**Model:** All CDP/CDP-C

**No.** 286R1

**Subject:** Will Not Play Disc / Skips After Optical Block Replacement

This bulletin supersedes Hi-Fi Service Bulletin No.286

RF signal waveform

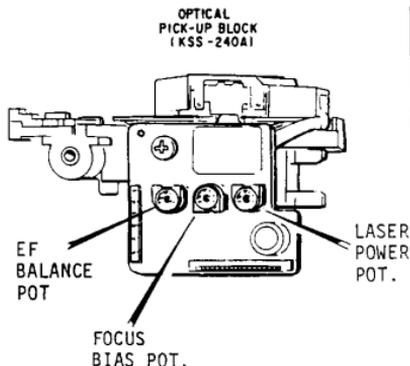
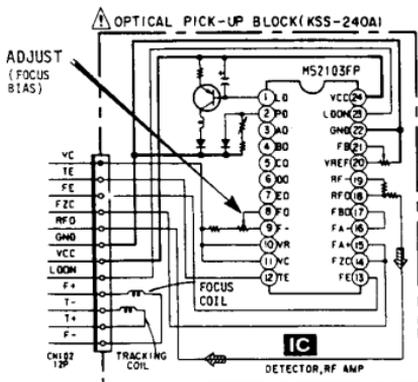
Unit will not read TOC or unit will skip after optical block has been replaced.

Focus Bias is out of adjustment. Adjust focus bias pot on optical block KSS-240A as follows:

1. Use a YEDS-18 disc.
2. Adjust the focus bias pot for the clearest eye pattern.

Clear RF signal waveform means that the shape "◇" can be clearly distinguished at the center of the waveform.
